SUBJECT: ADDITIONAL INFORMATION ON GROUND WATER MONITORING

RESPONSE TO REQUEST FOR ADDITIONAL INFORMATION ON GROUND WATER MONITORING PLAN FOR THE HEMATITE FACILITY

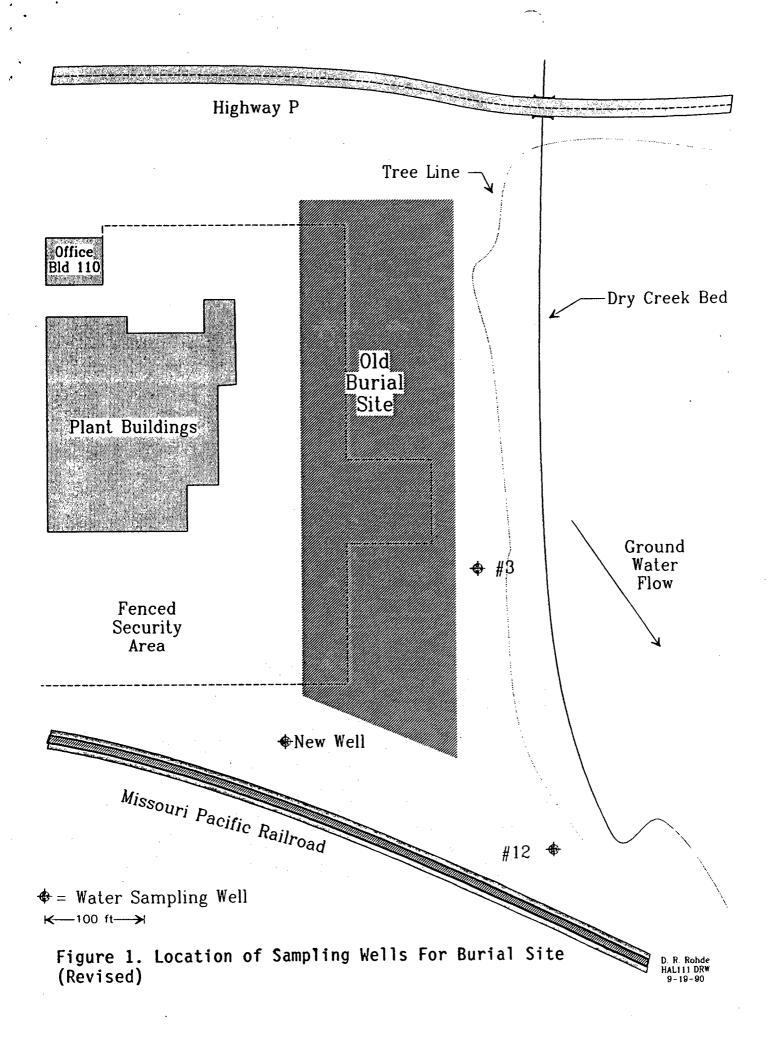
1. In place of Figure 1, provide a figure that shows the actual location of the burial ground and the direction of ground water flow.

Figure 1 has been revised to show the location of the old burial site and to indicate the direction of ground water flow.

Figure 2 (Rev.)
Locations of Sampling Wells for Evaporation Ponds

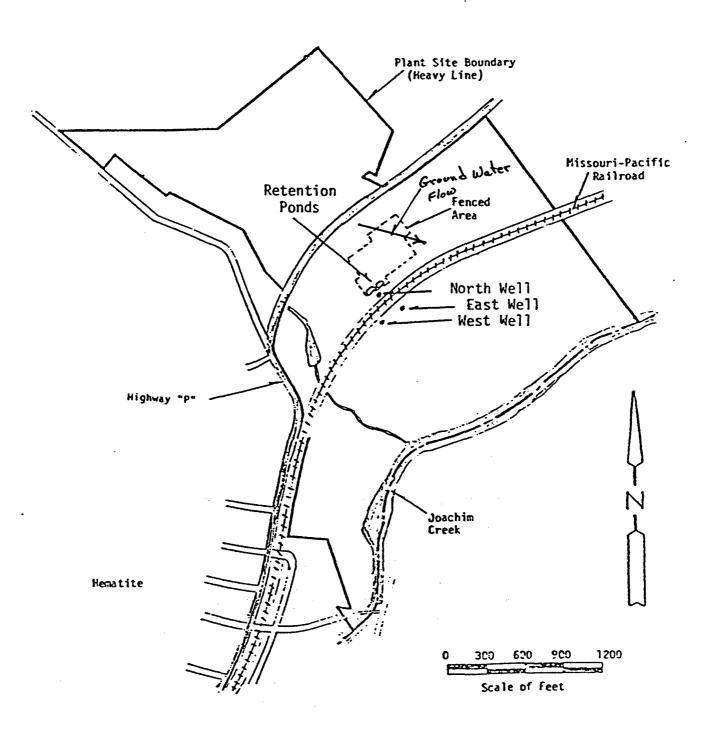
3. Indicate on Figure 2 the direction of ground water flow.

The direction of ground flow (ESE) has been indicated on Figure 2.
